**REVISED ATTACHMENTS - PRE-APPLICATION CONFERENCE**

**Advanced Builders Four-Plexes (2024-009-PAC)**

Meeting conducted on Wednesday, April 10, 2024, – 2 p.m.

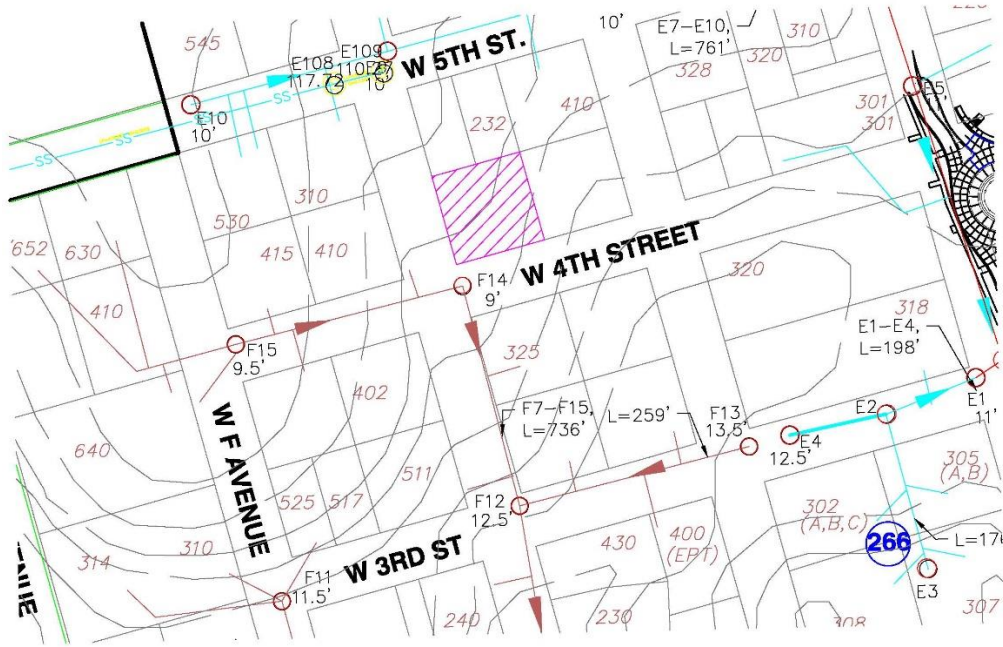
In order to grade this new half street, the elevation of the parking lot will need to be raised to allow the street frontage to meet a minimum longitudinal street grade of 15% and 2% cross slope. Because the access to the site is more than 290 LF from 3<sup>rd</sup> Street, at a minimum a hammerhead turn around will need to be installed on 4<sup>th</sup> Street to allow a fire truck to turnround. See attached schematic plan with contours.

A grading and erosion control plan will need to be submitted to show how this turnaround will be graded in W. D Avenue and W. 4<sup>th</sup> Street, without affecting the casino private parking lot. Coordination with the casino owner will be necessary for this proposed access.

Half street improvements will need to be constructed on the east side of W. E Avenue to local street standard, adjacent to Unit A. North of Unit A, the width of W. E. Avenue is only 17-feet wide. An asphalt taper will be needed along the north edge of the half street improvements, to taper to the existing street. W. E Avenue may need to be widened south of 5<sup>th</sup> to the site, to meet a minimum 20-foot wide road width. See the schematic drawing.

Sewer Connection Map

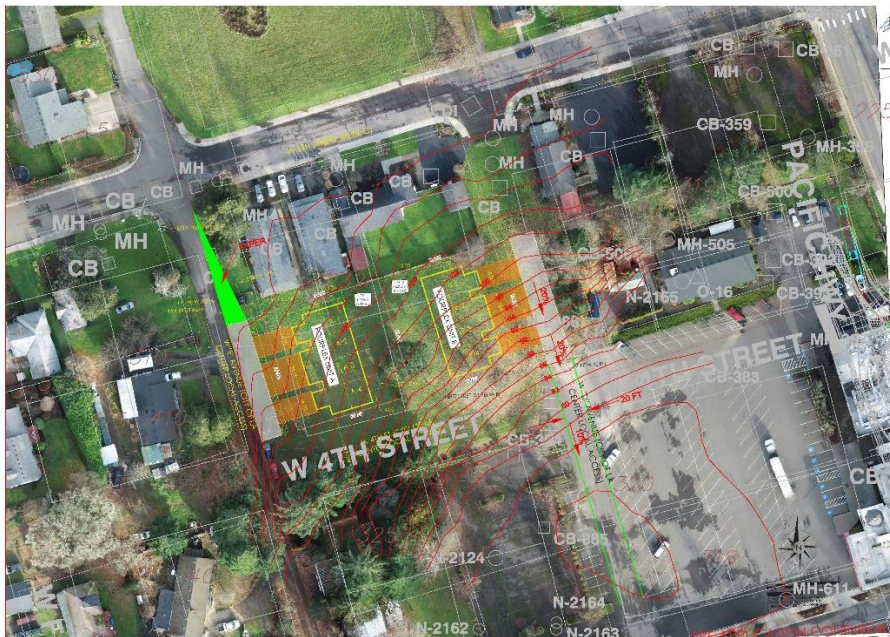
The applicant can connect to the sanitary sewer lateral from each unit to the existing manhole at the intersection of W. E Street and 4<sup>th</sup> Street via grinder pumps and force main. One grinder pump will be needed for each unit connecting to a force main in the east edge of W. E Street right of way. The city does not maintain grinder pumps or the force main in public right of way that serves a lot. This force main is considered a sewer lateral, and the installation and maintenance of this pipe shall be borne by the property owner.

The second option to connect to the public gravity sewer is in 3<sup>rd</sup> Street just south of W. D Avenue. A gravity public sewer main would need to be extended from the site along W. D Avenue to connect the existing manhole in 3<sup>rd</sup> Street to connect by gravity. See the attached schematic sewer map.

Figure 1: Mapped Landslide Hazard Area

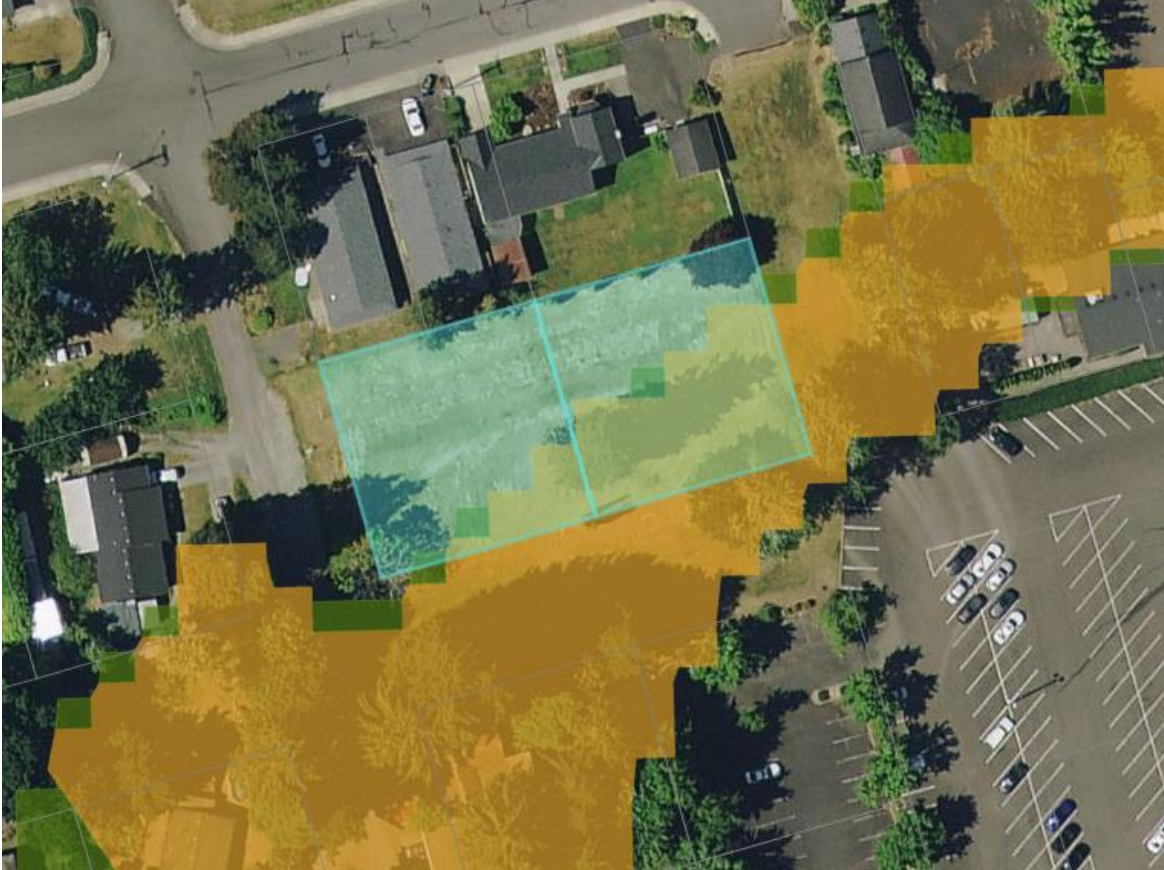
The southern portion of the site is mapped as a landslide hazard area (Figure 1) and is therefore must apply for a critical areas permit and file a critical area report (18.300.040) in the form of a geotechnical report. Alternatively, if the applicant submits a stamped letter from a geologist or geotechnical engineer stating that the landslide hazard is not present, then a critical areas permit is not required. Please refer to the definition of “landslide hazard area” in LCMC 18.300.030 and note that a geotechnical report may, nevertheless, still be required by the building official.

Figure 3: Mapped 10-year Time of Travel Zone (in teal)

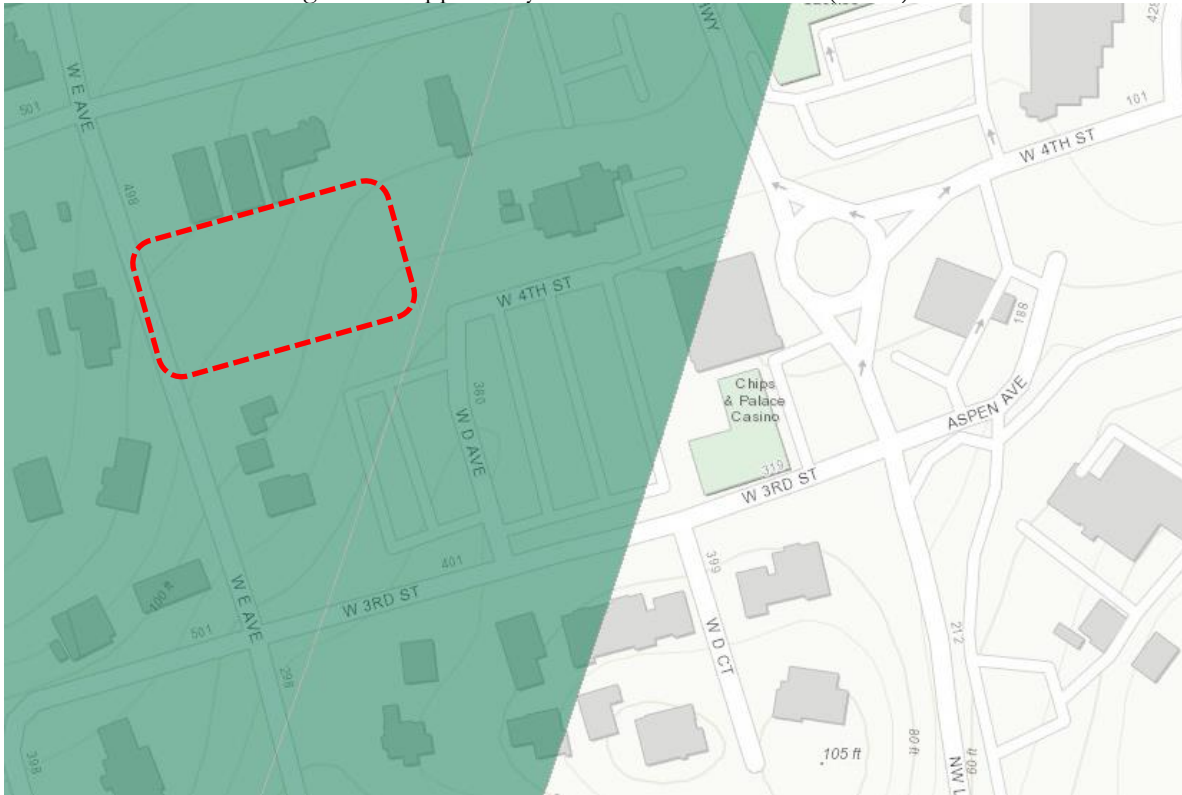
The project is mapped by the Washington State Department of Health within a 10-year time of travel zone for a Group A well (see Figure 3), which are regulated as Type I CARAs. However, as this project is a residential land use, these are typically exempt from CARA regulation in most jurisdictions. Staff will prepare a code interpretation letter that exempts residential uses from the requirement to provide a hydrogeological assessment since residential uses do not impact CARAs. The interpretation will omit the requirement for this project to apply for a critical areas permit for the CARA.
